# UNITED STATES PATENT AND TRADEMARK OFFICE

APPLICATION NO.	FILING DATE	FIRST NAMED INVENTOR	ATTORNEY DOCKET NO.	CONFIRMATION NO.
10/604,582	07/31/2003	Laurens Wolters	71358-0052	1581
20915	7590	09/13/2006	EXAMINER	
MCGARRY BAIR PC 171 MONROE AVENUE, N.W. SUITE 600 GRAND RAPIDS, MI 49503			PHAN, THIEM D	
			ART UNIT	PAPER NUMBER
			3729

## Office Action Summary

### **DETAILED ACTION**

Fig. 35

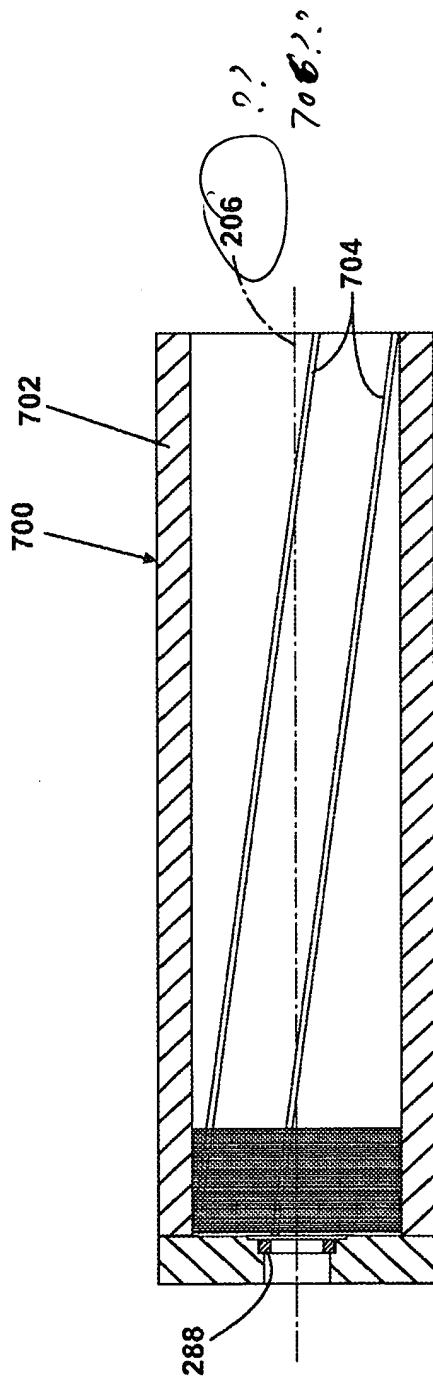
4. The drawings are objected to as failing to comply with 37 CFR 1.84(p)(4) because reference characters "206" in Fig. 35 and "706" in the amended paragraph 0112, line 4 have both

been used to designate “the longitudinal axis of the cage”. Corrected drawing sheets in compliance with 37 CFR 1.121(d) are required in reply to the Office action to avoid abandonment of the application. Any amended replacement drawing sheet should include all of the figures appearing on the immediate prior version of the sheet, even if only one figure is being amended. Each drawing sheet submitted after the filing date of an application must be labeled in the top margin as either “Replacement Sheet” or “New Sheet” pursuant to 37 CFR 1.121(d). If the changes are not accepted by the examiner, the applicant will be notified and informed of any required corrective action in the next Office action. The objection to the drawings will not be held in abeyance.

Do not enter!  
T.P. 9/17/06
